APPLICATION NO.	FILING DATE	FIRST NAMED INVENTOR	ATTORNEY DOCKET NO.	CONFIRMATION NO.
10/524,631	03/29/2007	Shigemitsu Kikuchi	KUD-003	1444

Office Action Summary	Application No. 10/524,631	Applicant(s) KIKUCHI ET AL.	
	Examiner JONATHAN KOAGEL	Art Unit 3744

DETAILED ACTION

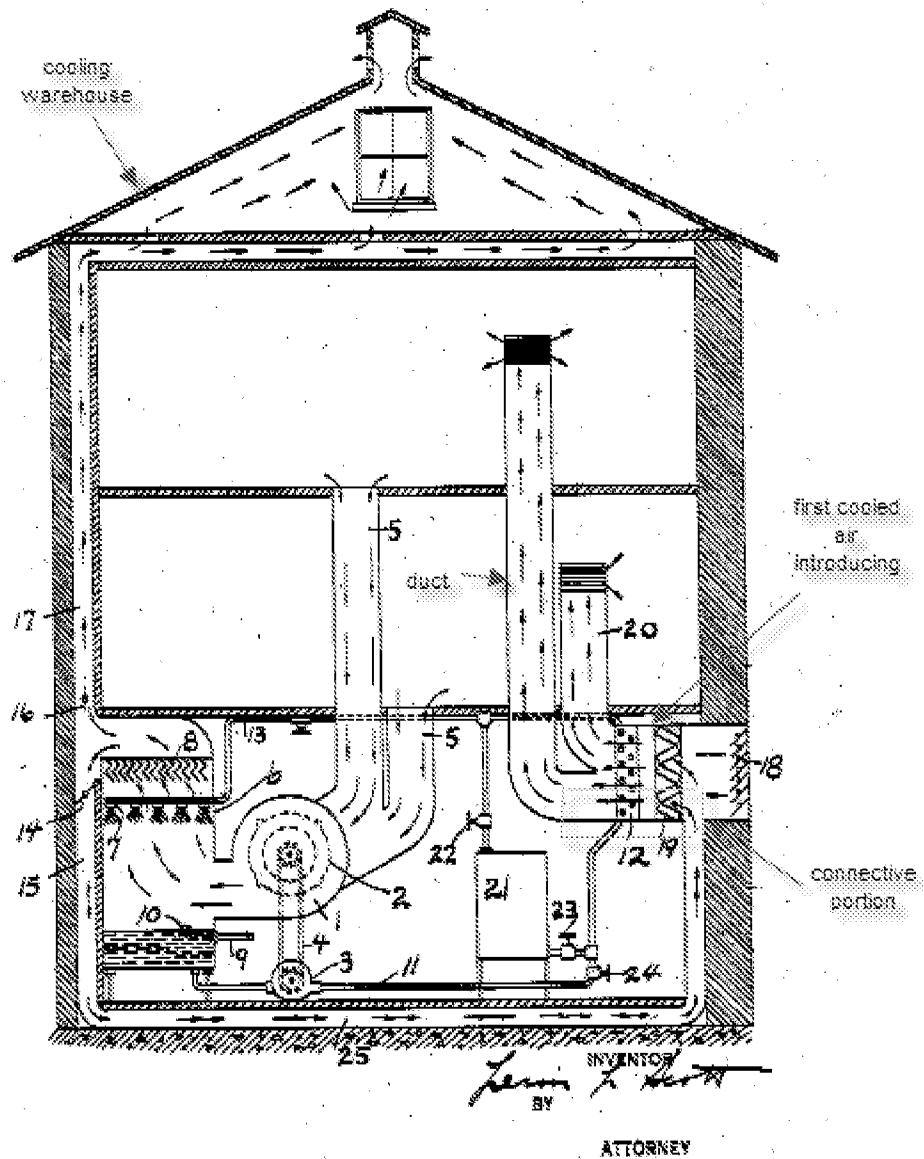
Regarding claim 1, Scott teaches in fig. 1, a cooling warehouse (See annotated figure below) comprising, a first cooled air introducing pipe (See annotated figure below) introducing a first cooled air cooled by an air refrigerant type cooling apparatus 12, a second cooled air introducing pipe 25 taking in second cooled air in said cooling warehouse, wherein said second cooled air introducing pipe 25 is set inside of said cooling warehouse, a duct (See annotated figure) in the cooling warehouse, a connective portion (See annotated figure) inside the cooling warehouse connecting the

first cooled air introducing pipe to the duct in the cooling warehouse at a downstream side of the connective portion with the second cooled air introducing pipe 25, wherein the connective portion (see annotated figure) is capable of mixing said first cooled air and said second cooled air.

Regarding claim 7, Scott teaches the invention as disclosed above and further teaches in fig. 1, a cooled air feeding fan 1 disposed in the warehouse (see annotated figure) and capable of supplying the second cooled air to be mixed with the first cooled air at the connective portion (see annotated figure).
